HAVEN VALLEY PUD DEVELOPMENT / PRELIMINARY PLAN

TRACT MAP, LOT TYPICALS & ADJACENT PROPERTY OWNERS

PUD PRELIMINARY
 SITE PLAN

PUD Development Plan - _v4.pdf Markup Summary 5-9-2022

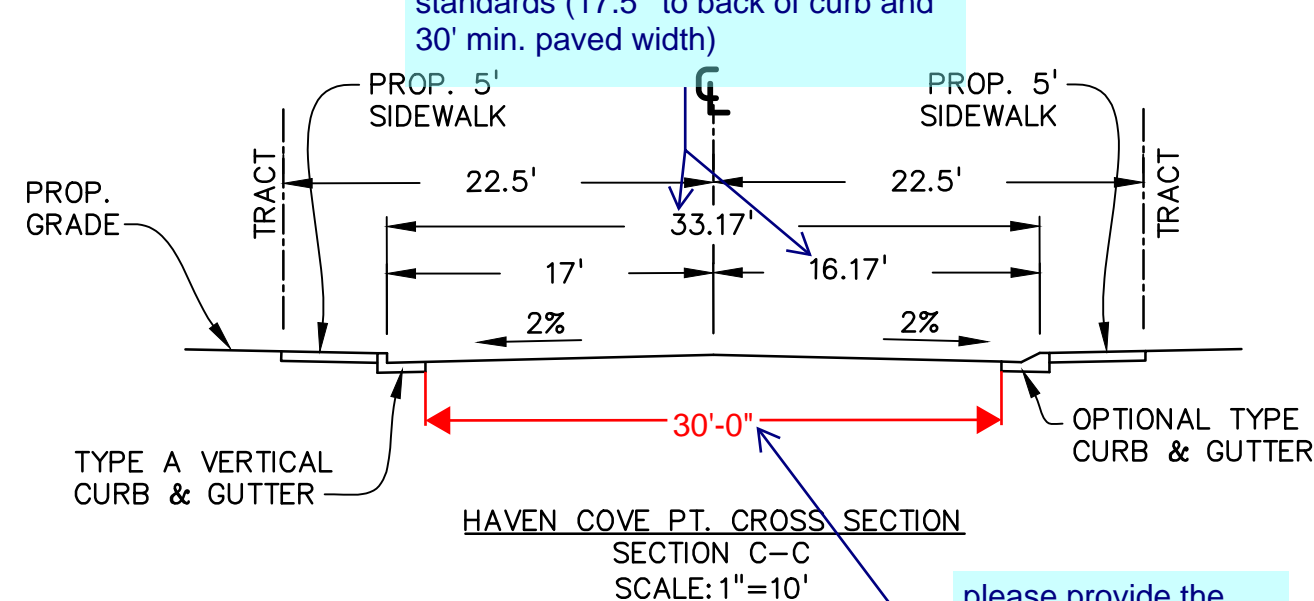
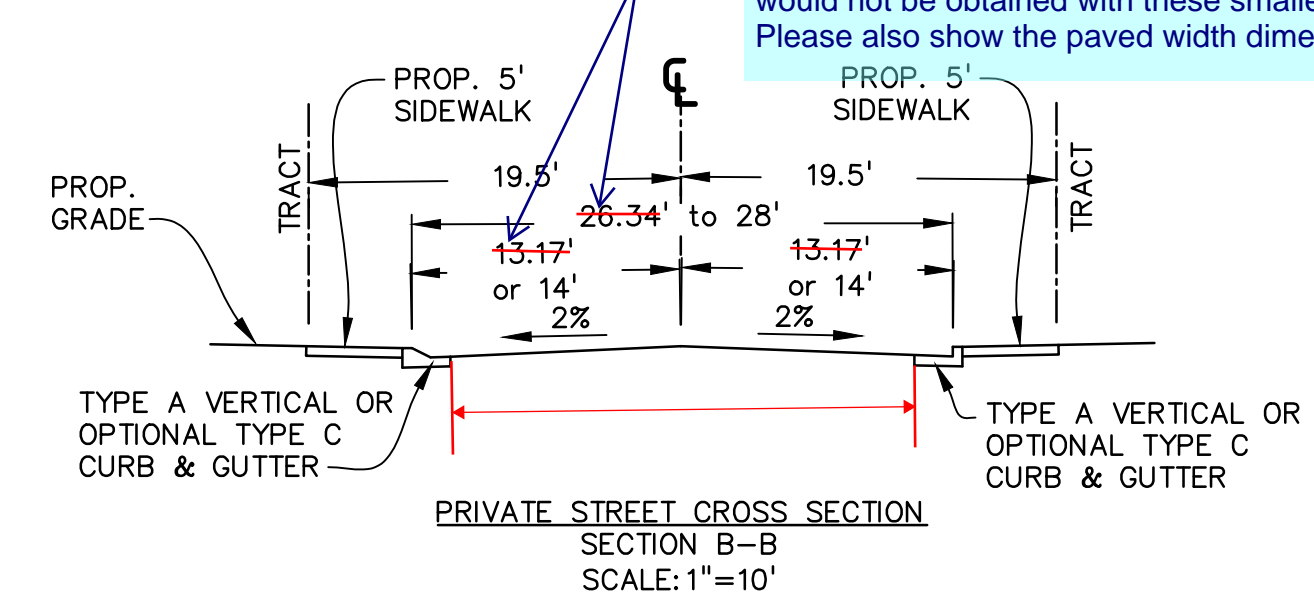
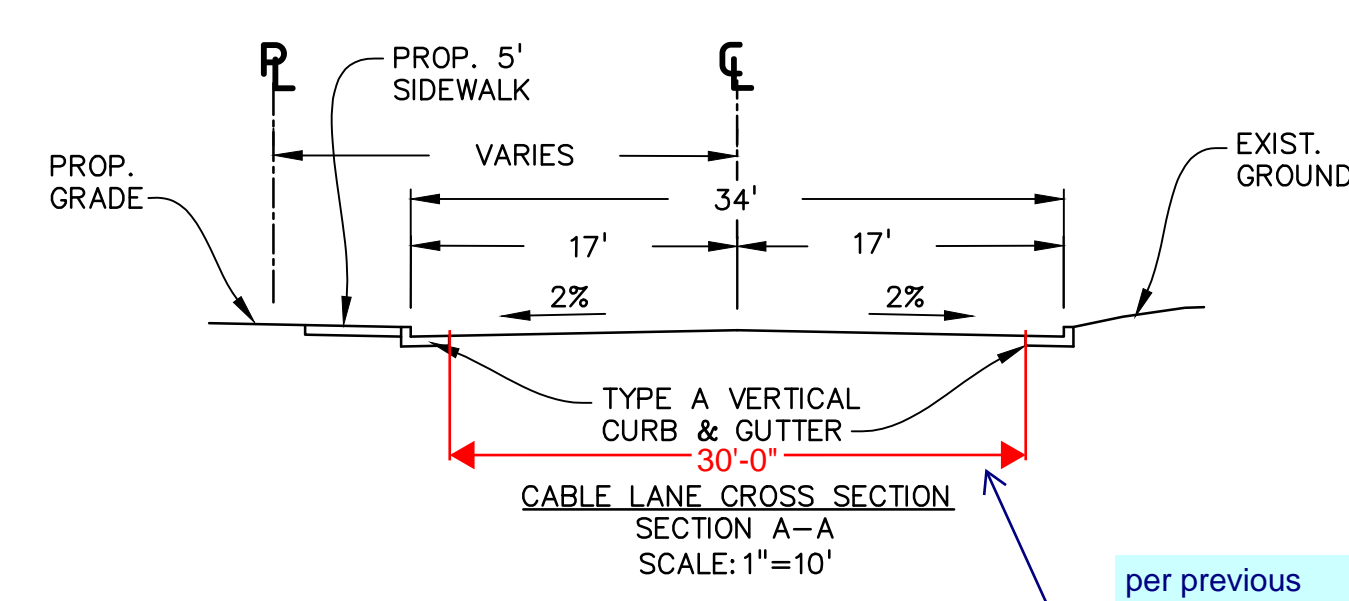
Recommend showing the distance on the cross sections to the back of curb to be consistent with the sections on the PUD plan and for clarity.

per previous comment, please provide the paved width distance.

please provide the paved width distance

PRELIMINARY GRADING PLAN

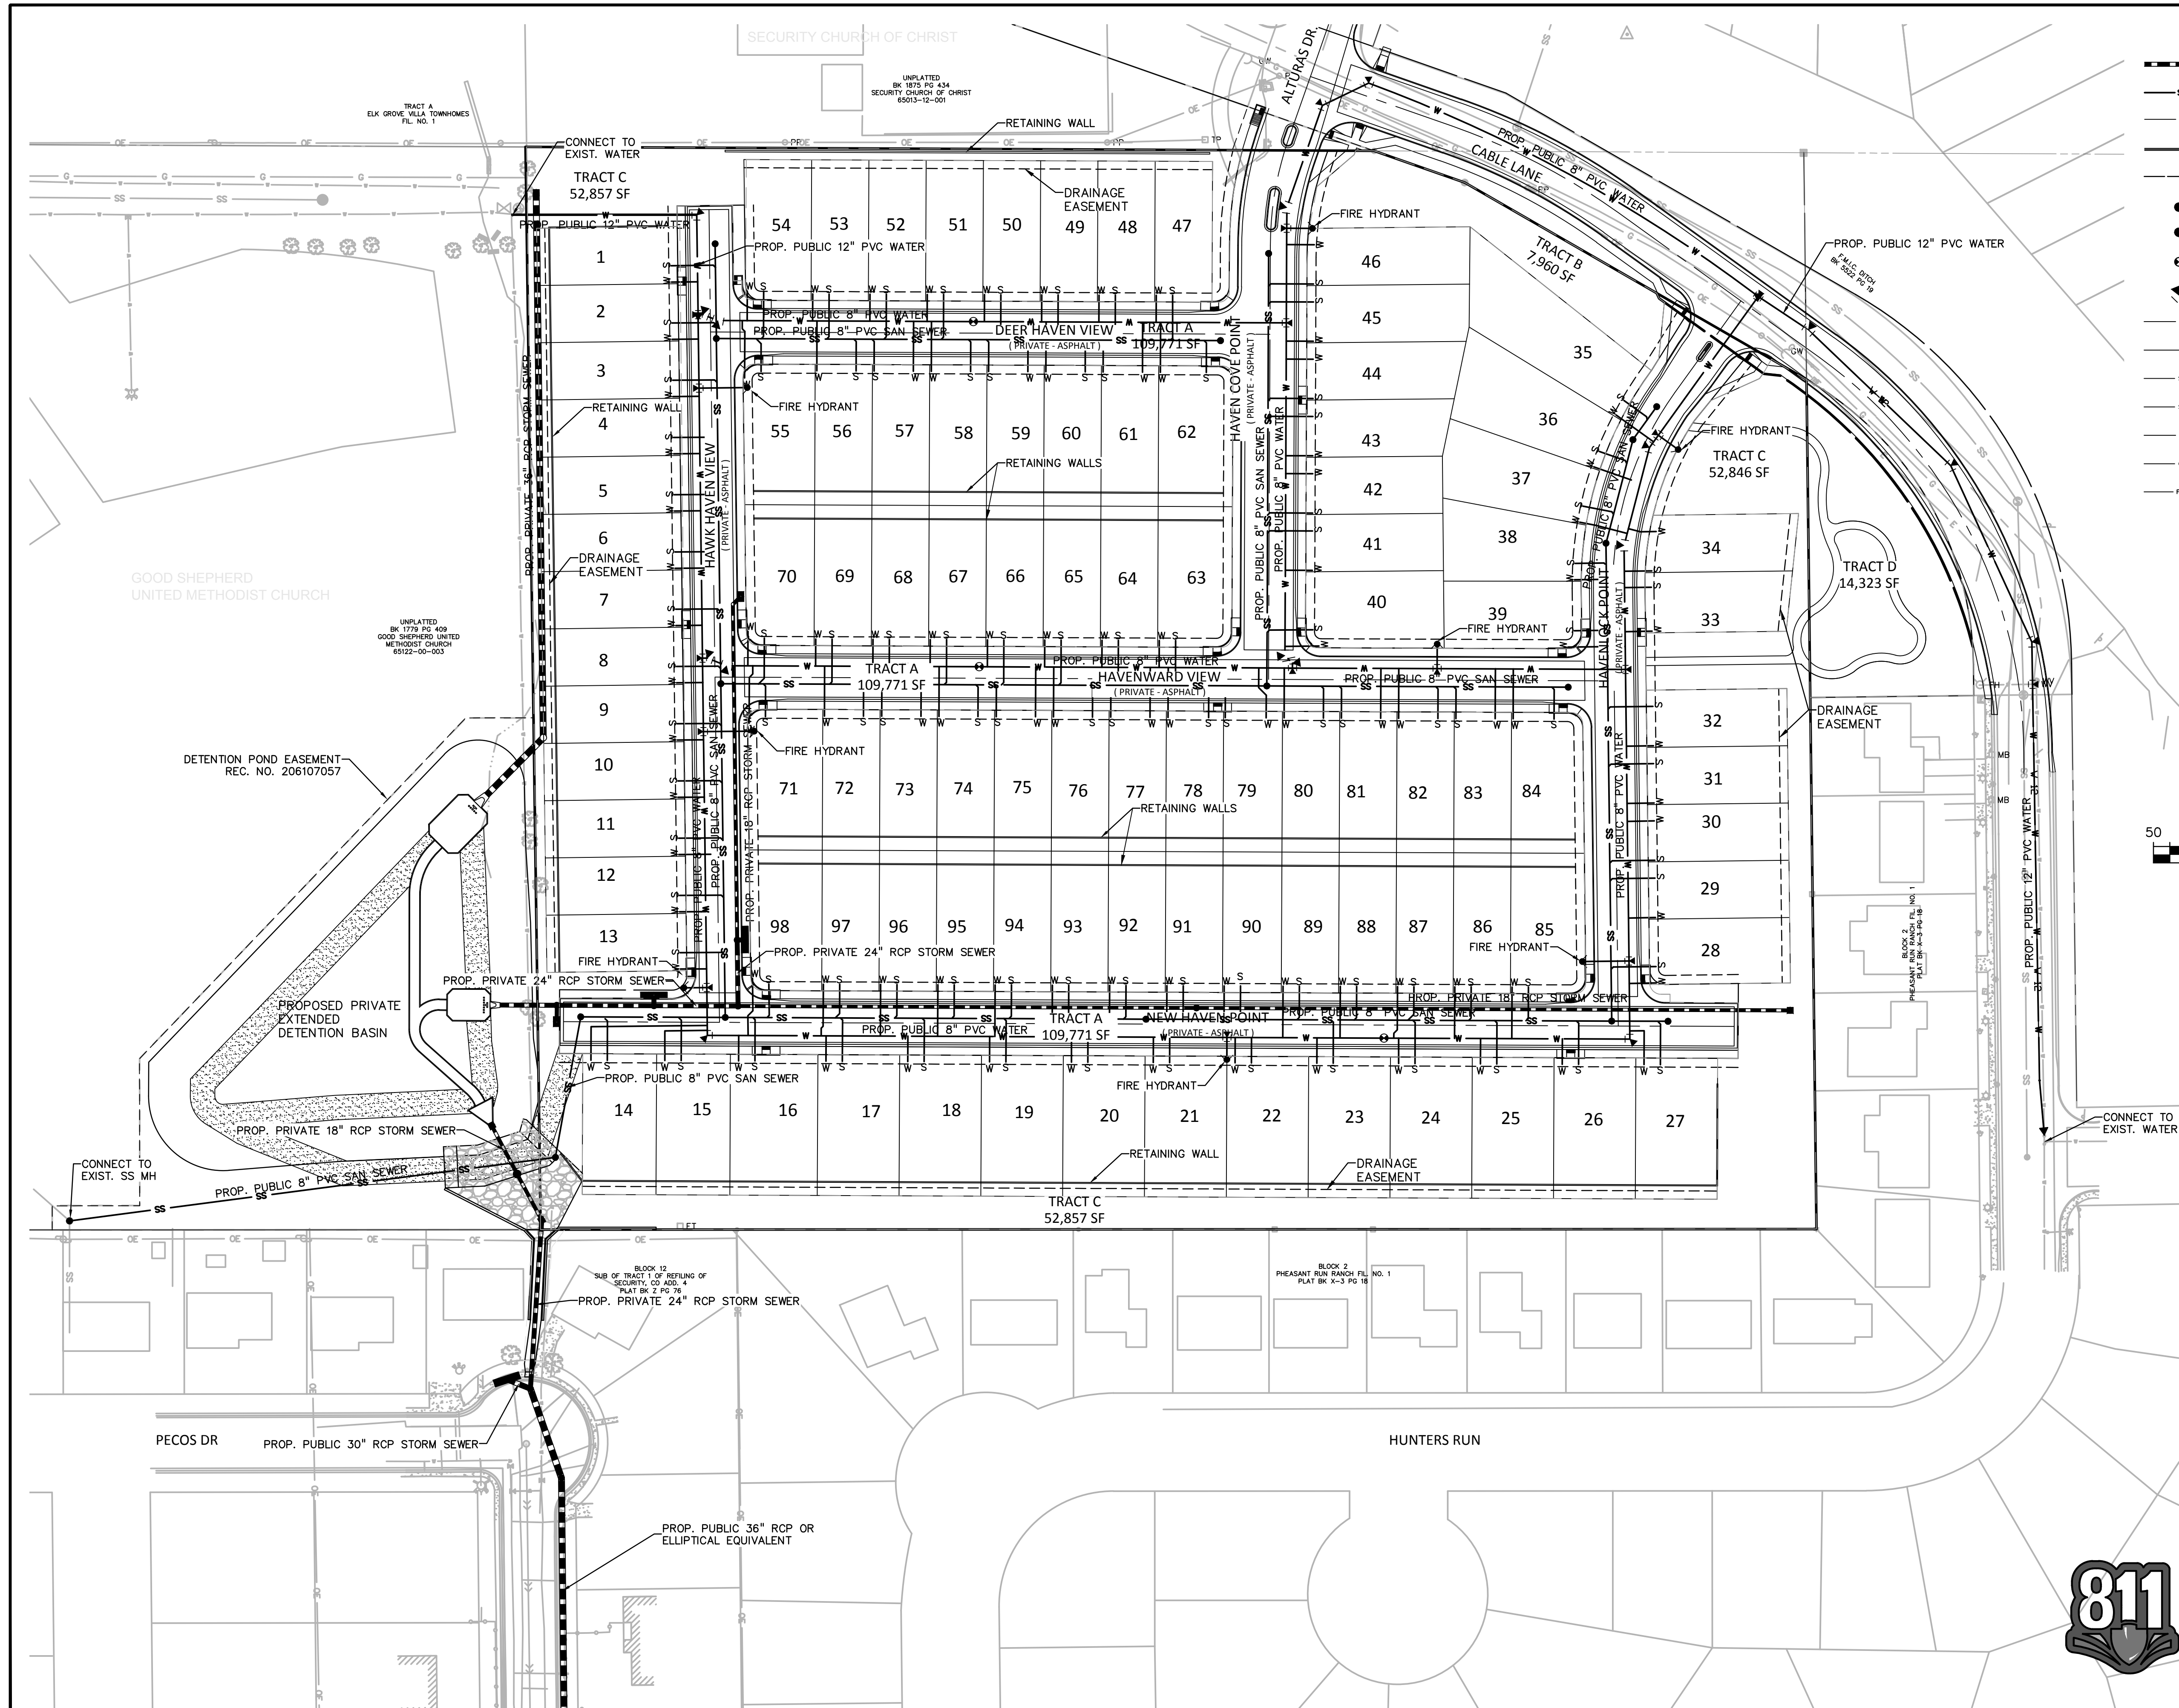
Please remove the distance shown. The smallest roadway per the PUD and TIS is an urban local low volume roadway which will have a minimum 24' paved width which would not be obtained with these smaller distances. Please also show the paved width dimension.

please revise the distance such that it meets the urban local roadway standards (17.5' to back of curb and 30' min. paved width)

ALTERNATIVE LANDSCAPE PLAN

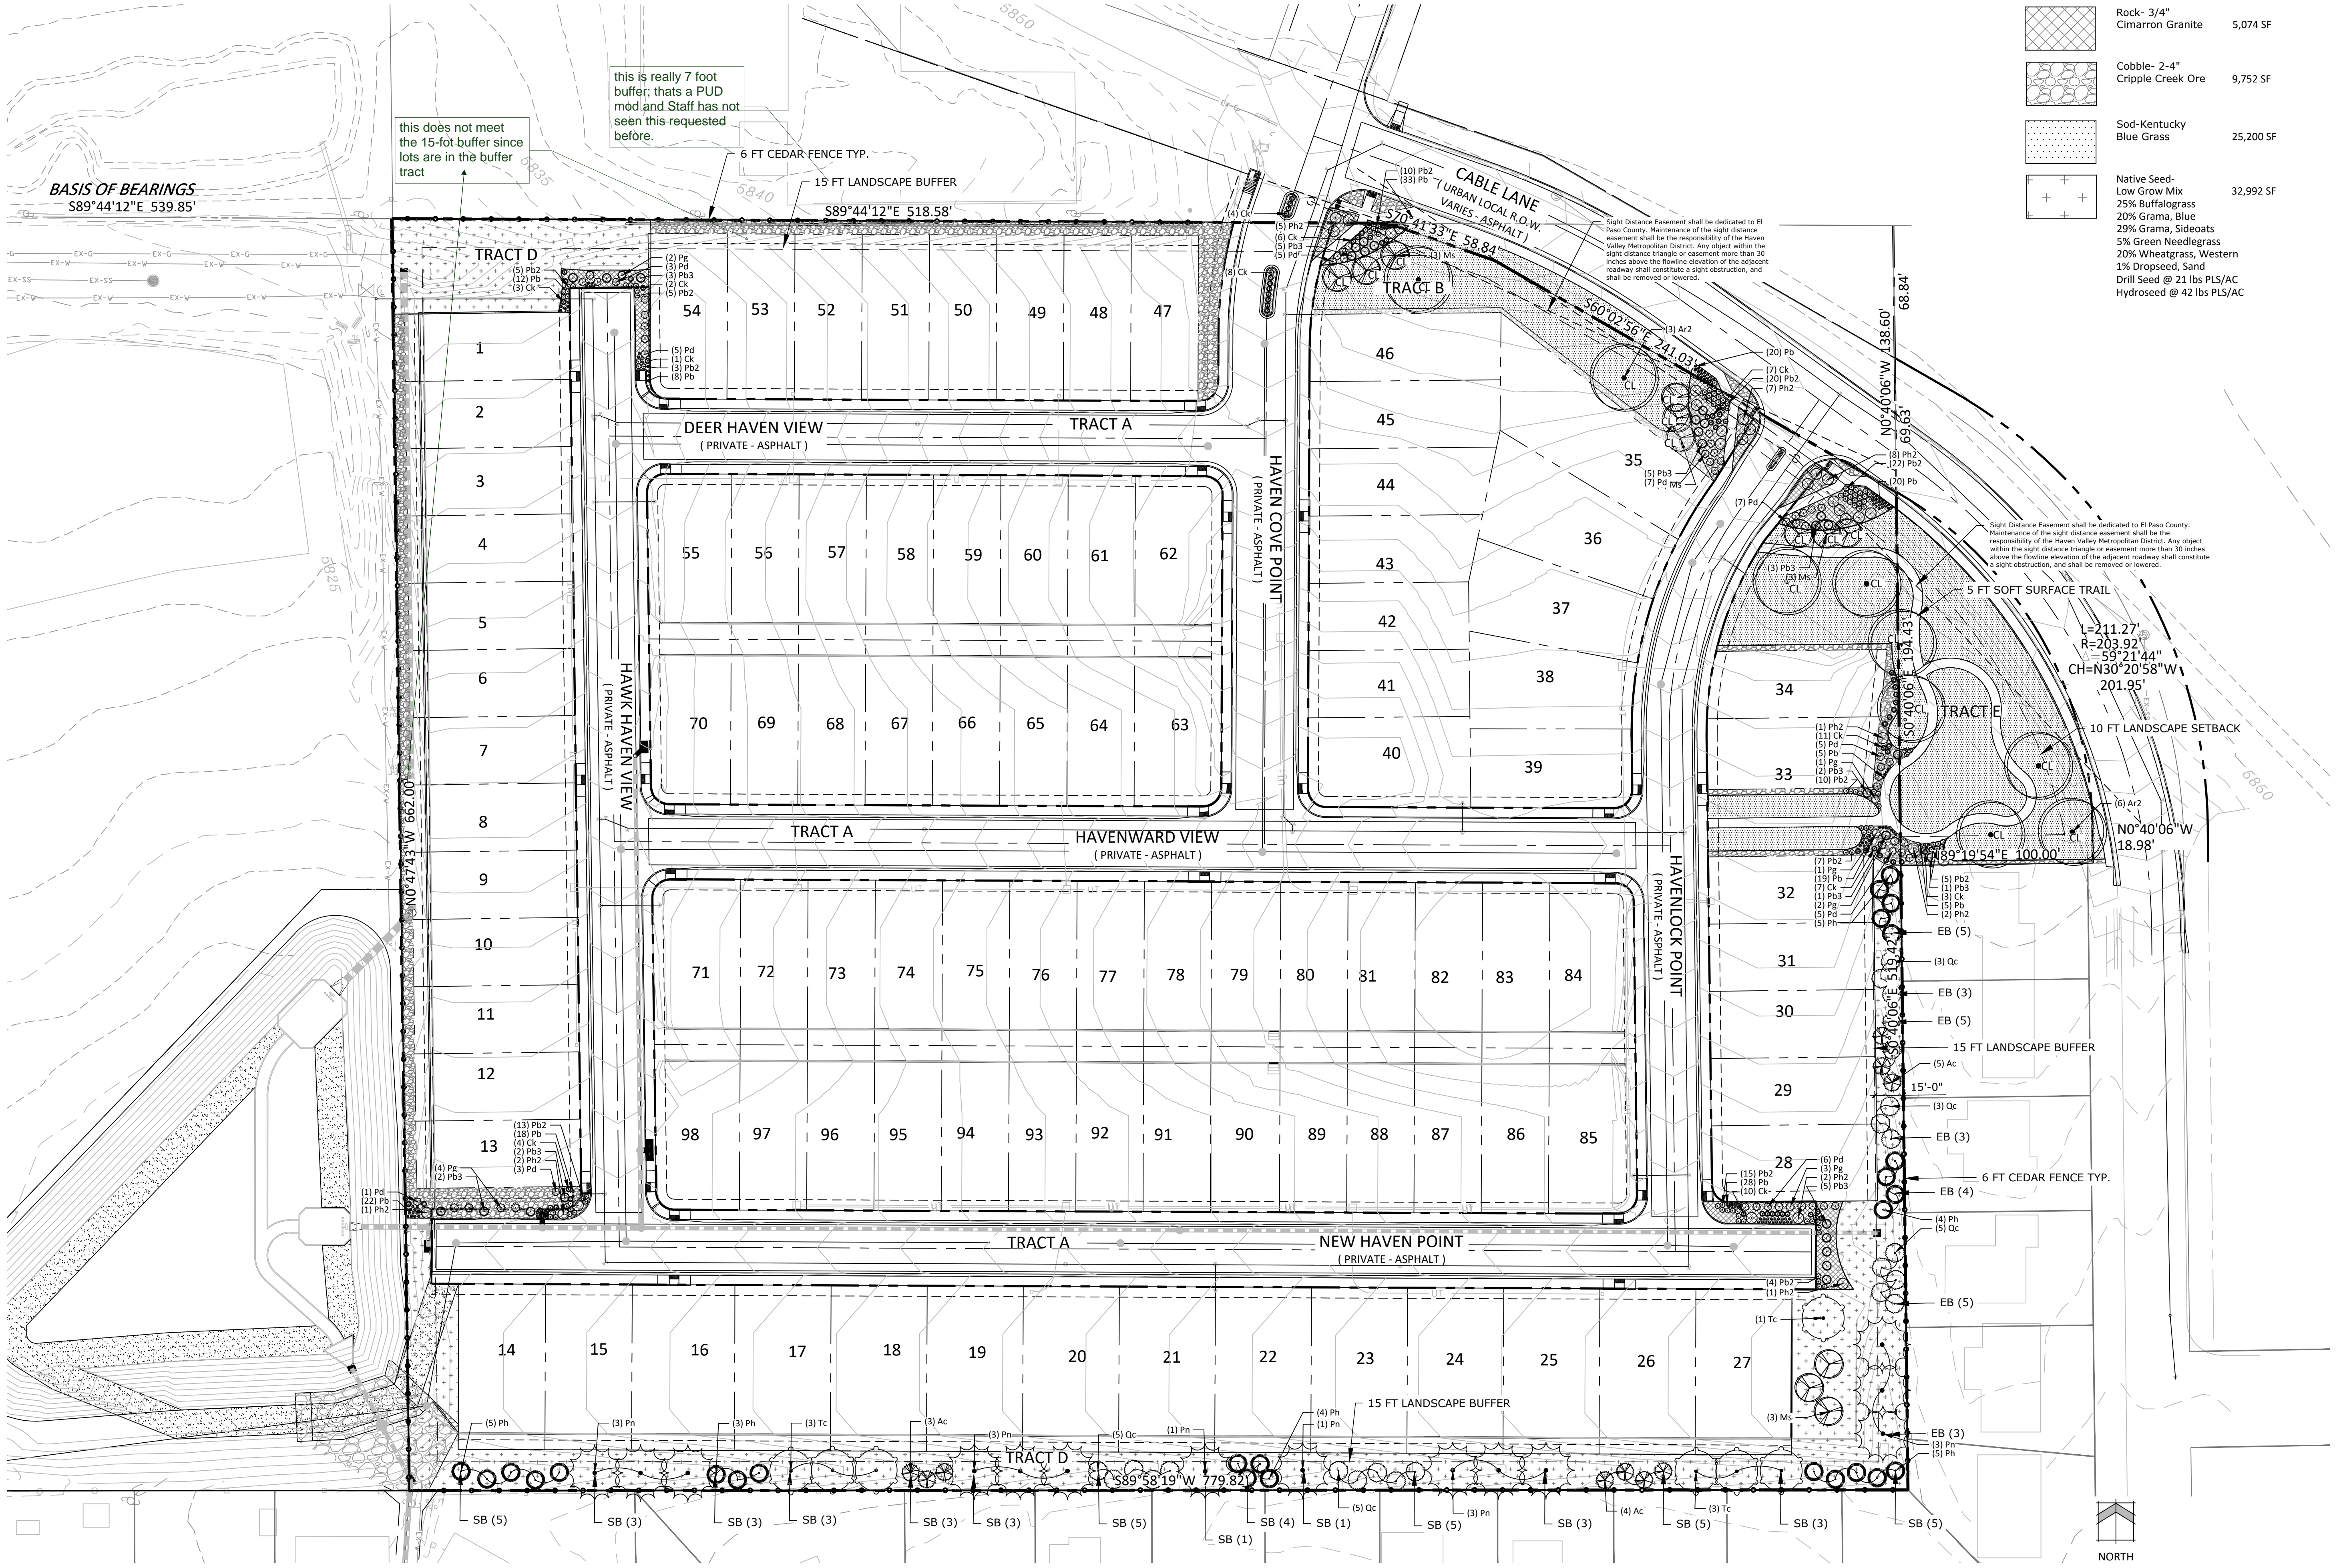
this does not meet the 15-foot buffer since lots are in the buffer tract

this is really 7 foot buffer; thats a PUD mod and Staff has not seen this requested before.
